SECTION 009111 - ADDENDUM NUMBER 4

- 1.1 **DATE: FEBRUARY 9, 2026**
- 1.2 **PROJECT: SHERIDAN PUBLIC LIBRARY BUILDING ADDITION, RENOVATIONS & SITE IMPROVEMENTS:**
- 1.3 **PROJECT NUMBER: 25050**
- 1.4 **OWNER: SHERIDAN PUBLIC LIBRARY, 103 W 1ST STREET, SHERIDAN, IN 46069**
- 1.5 **ARCHITECT: ODLE MCGUIRE SHOOK MATTHEW R. MAYOL #IN19900090**

P002
PLUMBING DETAILS
AND SCHEDULES

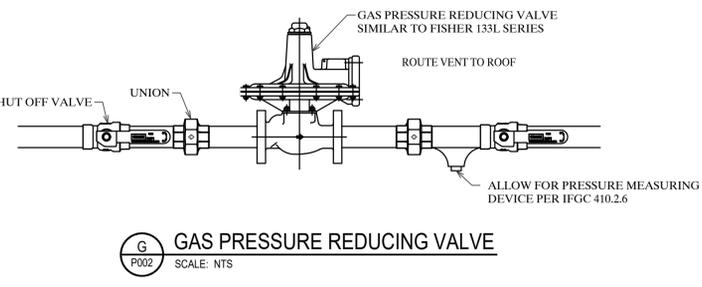
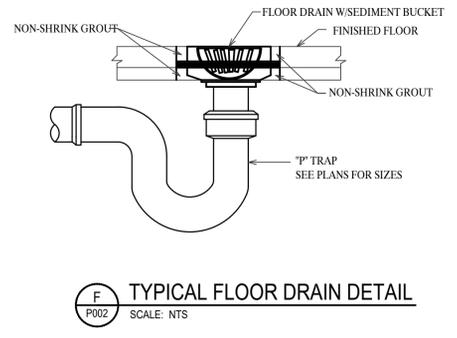
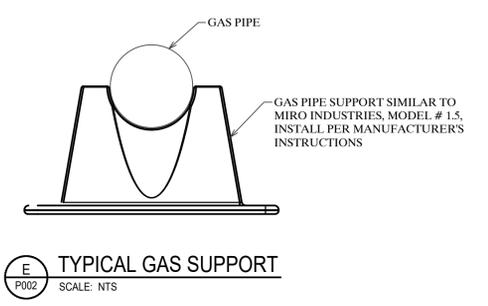
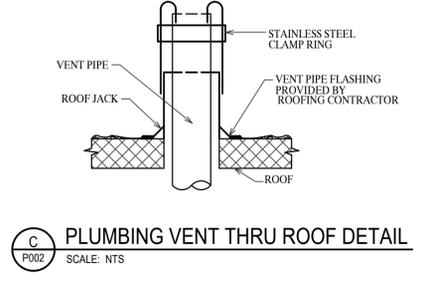
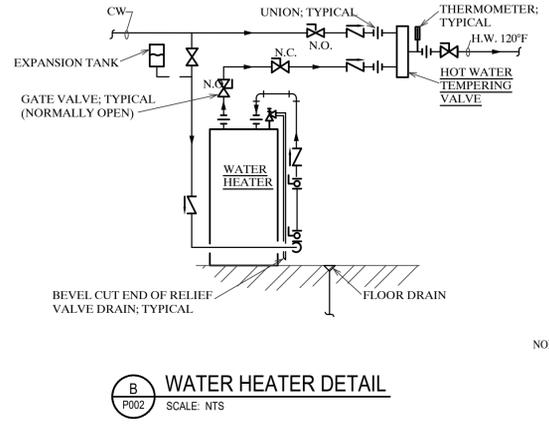
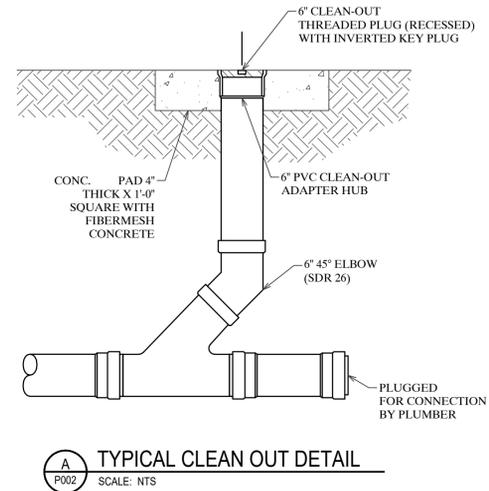
6.2 P002 - PLUMBING DETAILS AND SCHEDULES

- A. Add adjustable floor drain per revision triangle 3.

DRAIN SCHEDULE			
FIXTURE ID	MANUFACTURER	MODEL & (#) NO.	SIZE
FD-1	ZURN	FD2210 FLOOR DRAIN	MATCH EXISTING SIZE
CO	ZURN	Z1400 CLEAN OUT	3"
FS-1	ZURN	Z1995 SANI-FLOOR RECEPTOR	24"x16"-6" OUTLET
YCO	ZURN	YARD CLEAN OUT	4"
WCO	ZURN	Z1446 WALL CLEAN OUT	3"

PD101

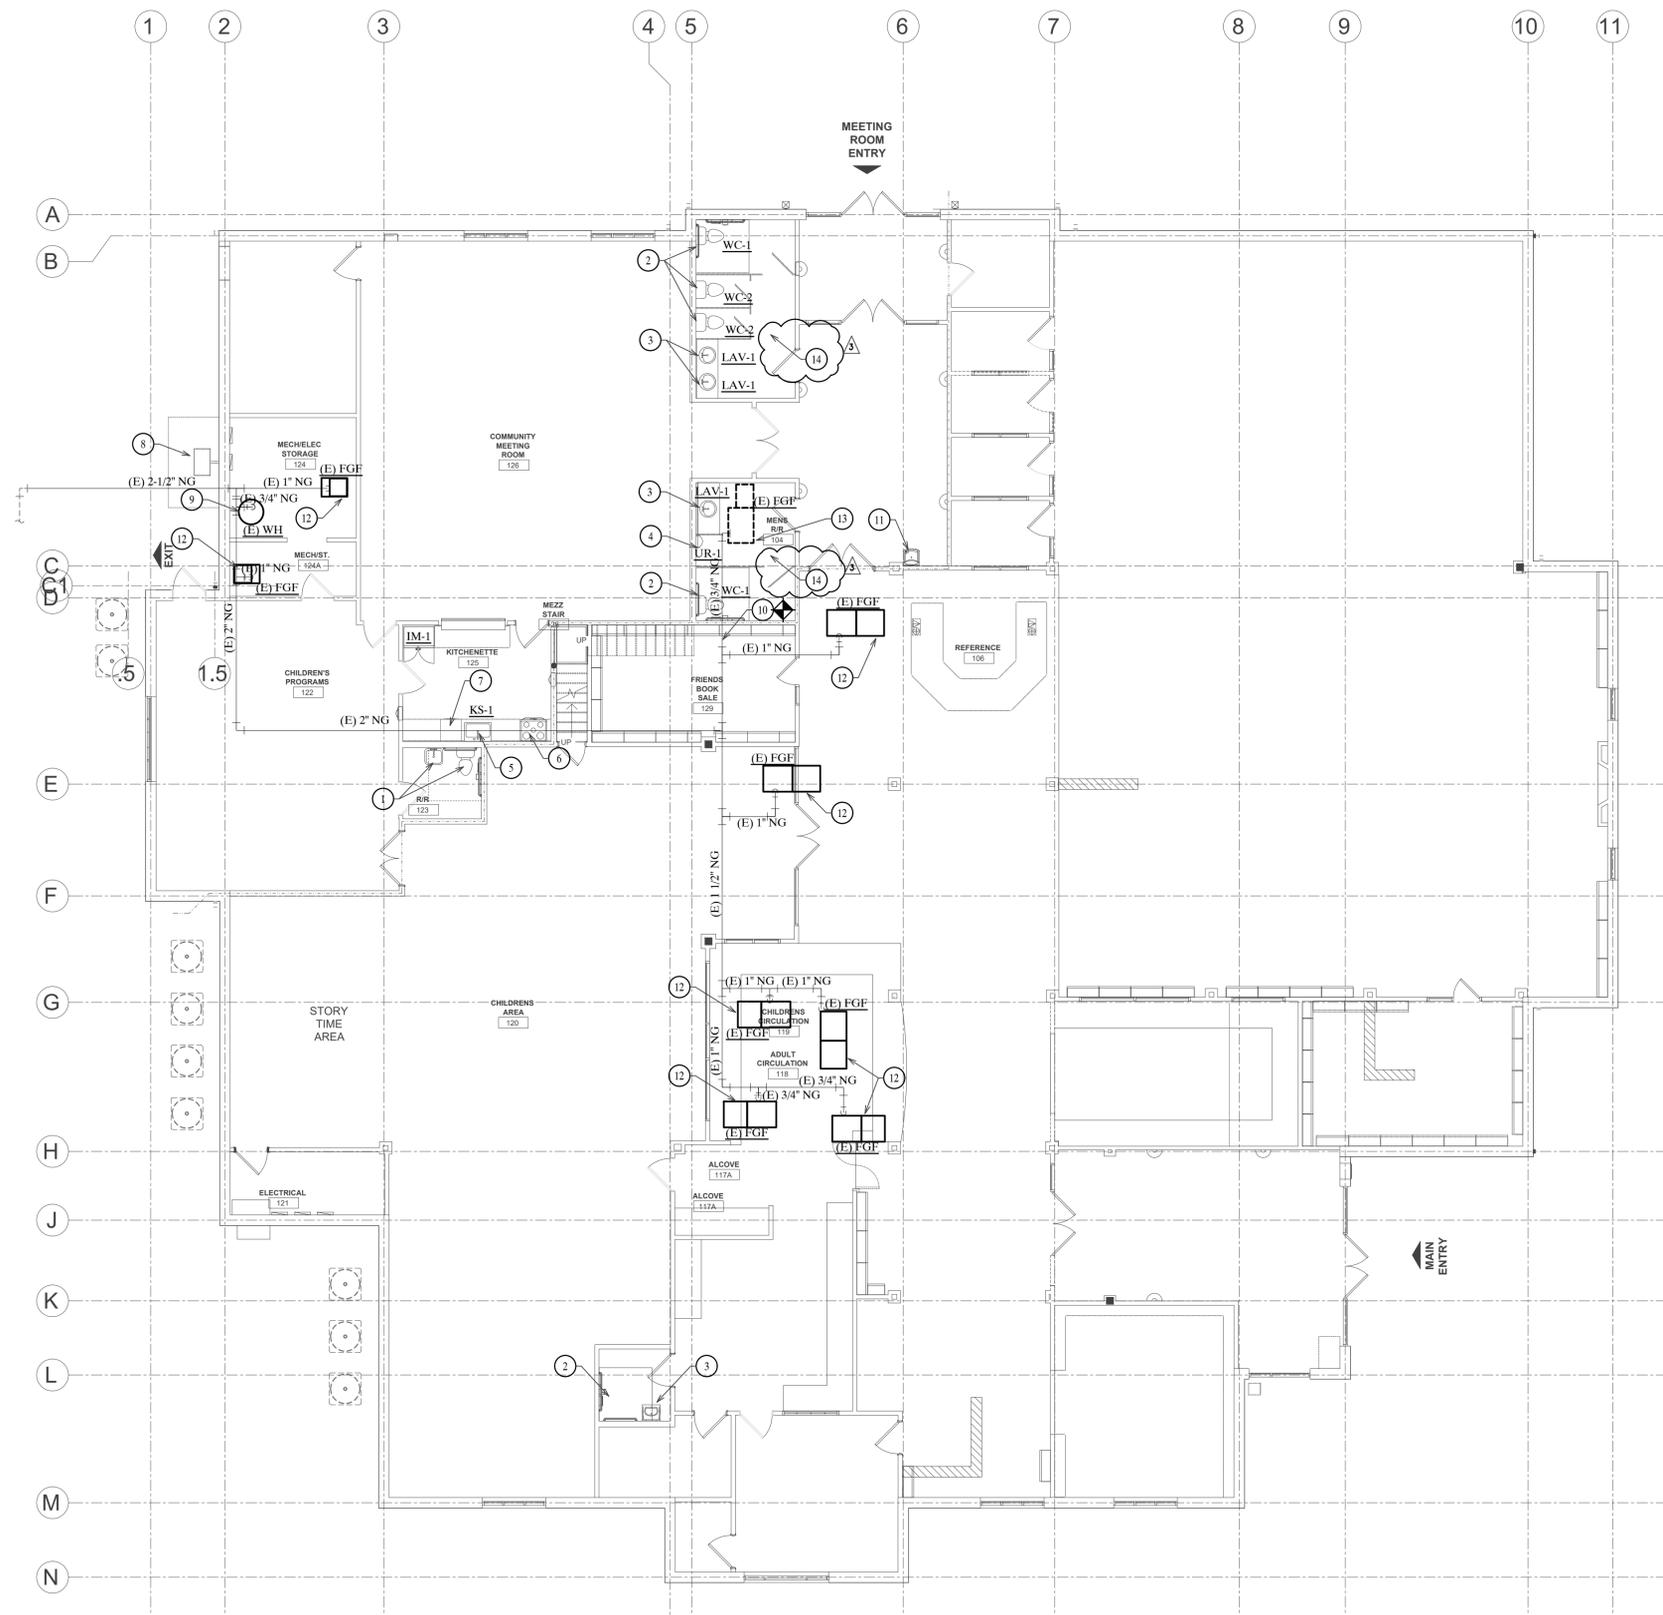
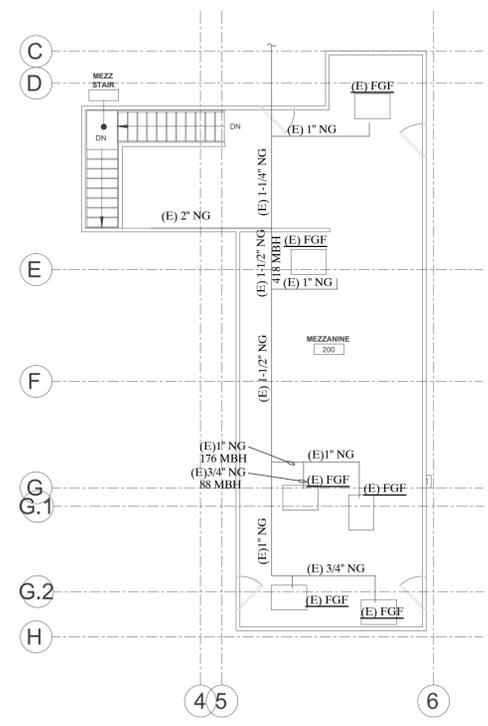
6.3 PD101 PLUMBING DEMOLITION PLANS

- A. Remove floor drains in Women & Mens Restrooms per revision triangle 3.

13. REMOVE EXISTING FURNACE. FIELD VERIFY EXISTING CONDITIONS. CAP AND RECONNECT ALL PIPING.
14. DEMOLISH ALL EXISTING RESTROOM FLOOR DRAINS AND REPLACE THEM WITH NEW ADJUSTABLE HEIGHT FLOOR DRAINS.

P101

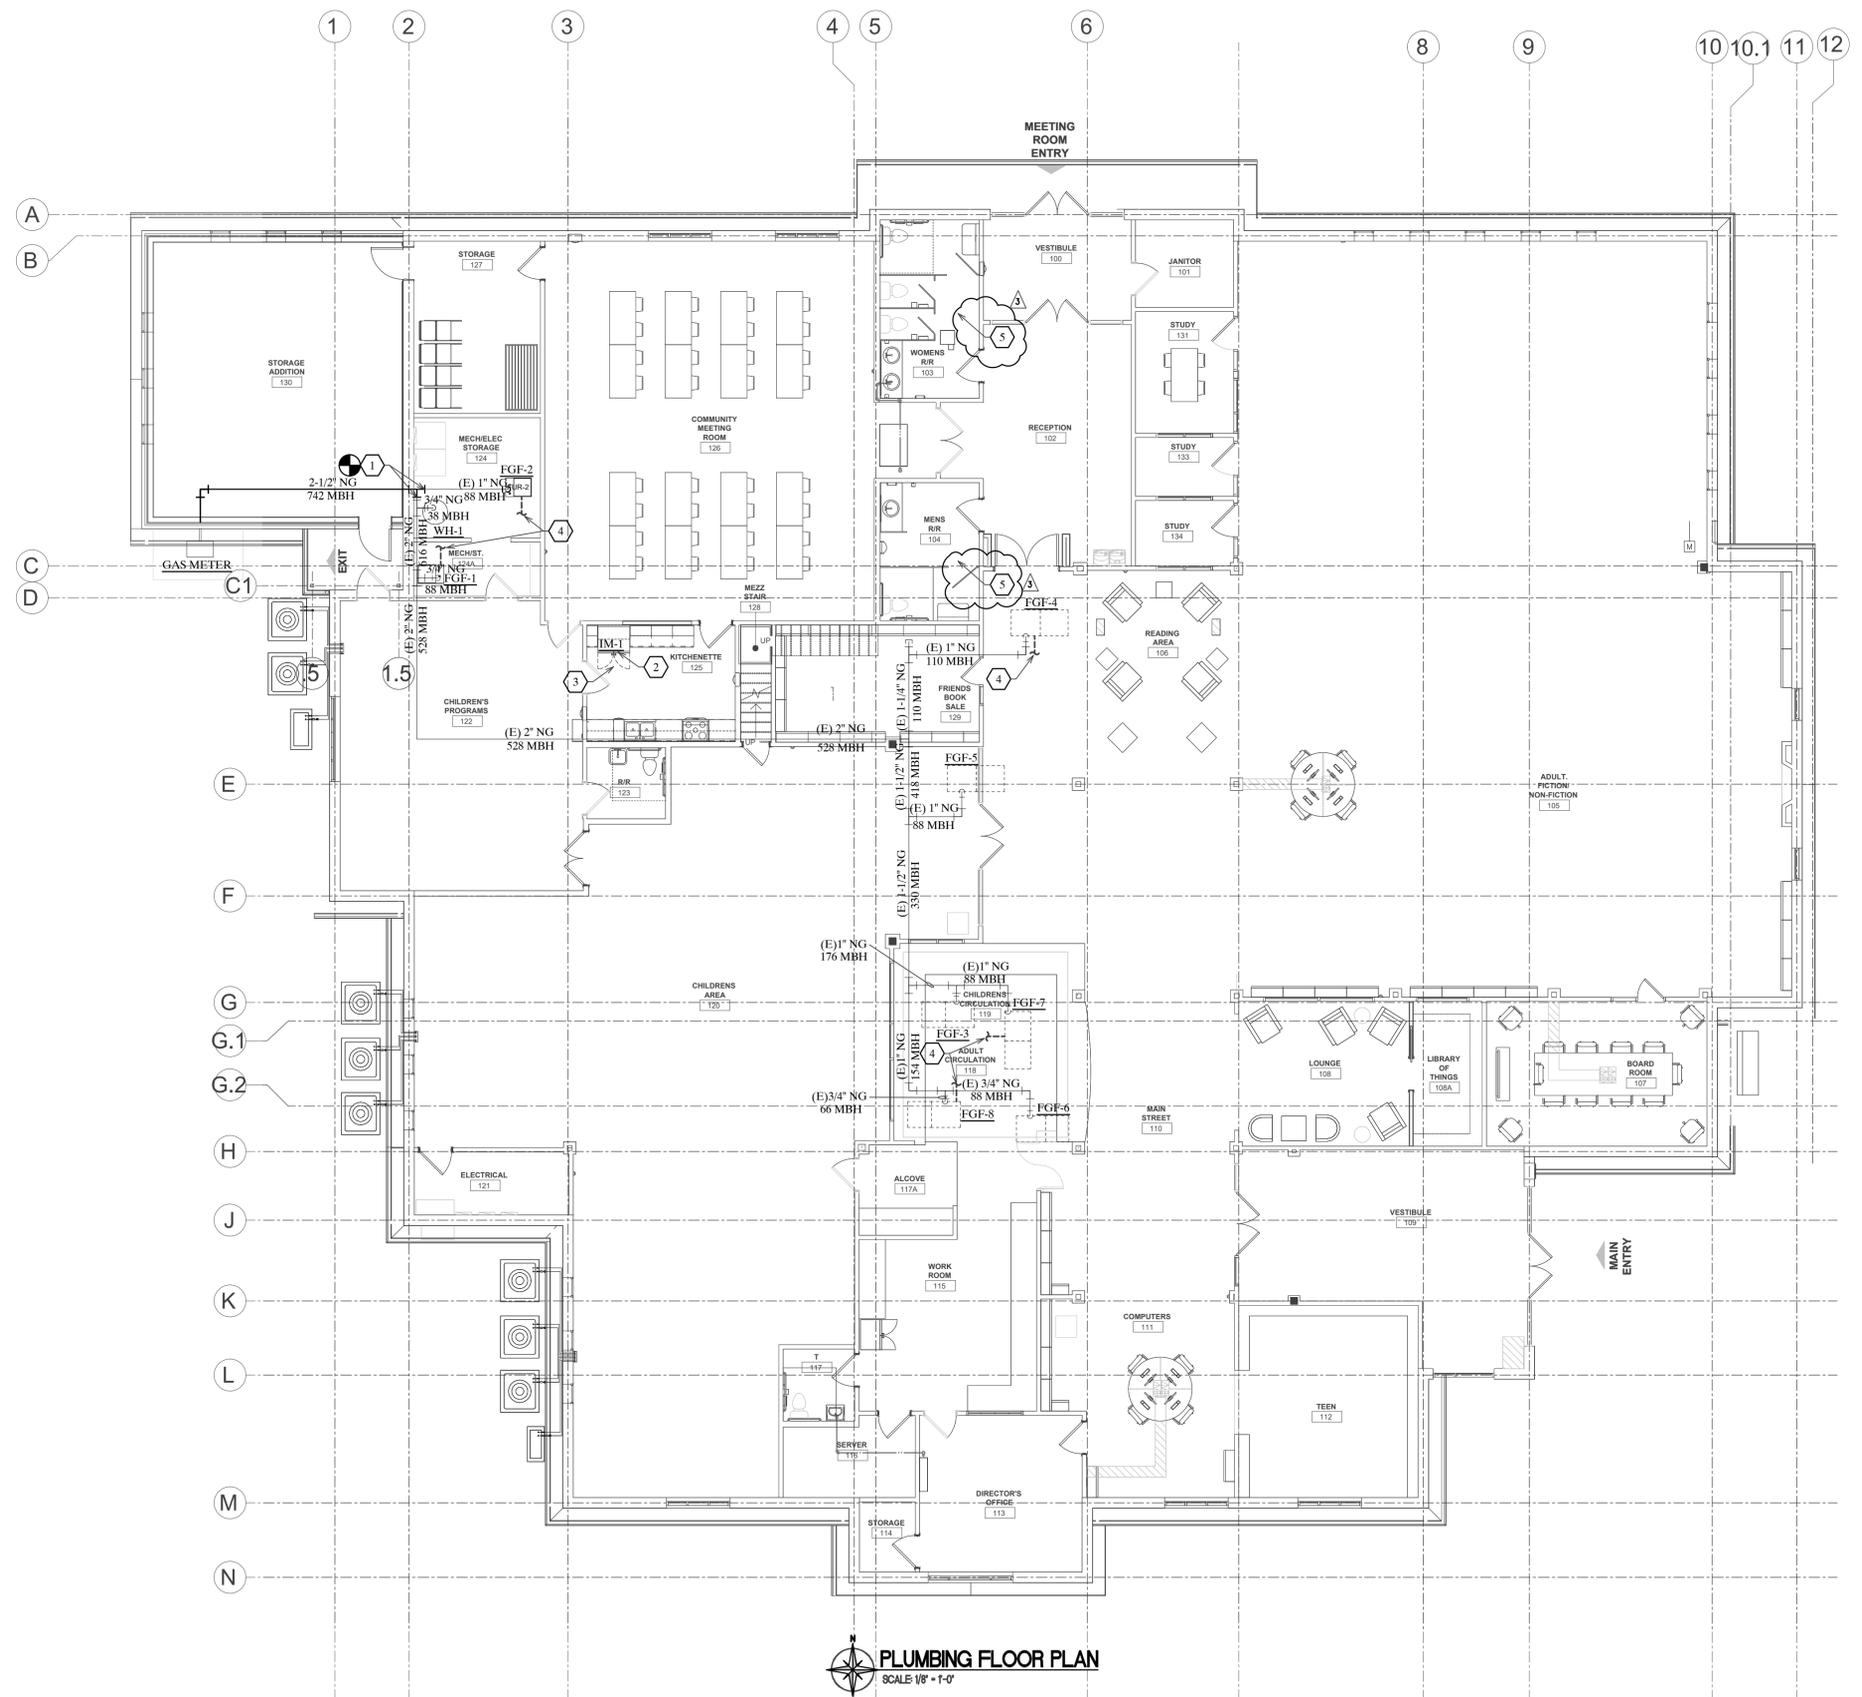
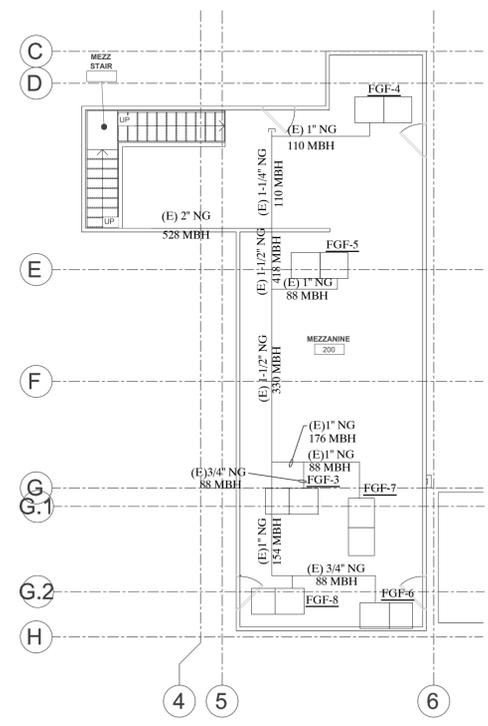
6.4 P101 PLUMBING FLOOR PLANS

- A. Provide new floor drains in Women & Mens Restrooms per revision triangle 3.

- # KEYED PLAN NOTES:**
- CONNECT NEW PIPE TO EXISTING PIPES. FIELD VERIFY EXACT LOCATION.
 - 1/2" COLD WATER PIPE DOWN TO ICE MAKER.
 - ROUTE 3" SANITARY PIPE FROM FLOOR DRAIN TO THE SANITARY MAIN.
 - 3/4" COLD WATER TO CONNECT TO EXISTING COLD WATER PIPING. FIELD VERIFY EXACT LOCATION.
 - REPLACE EXISTING FLOOR DRAINS WITH NEW ADJUSTABLE HEIGHT FLOOR DRAINS
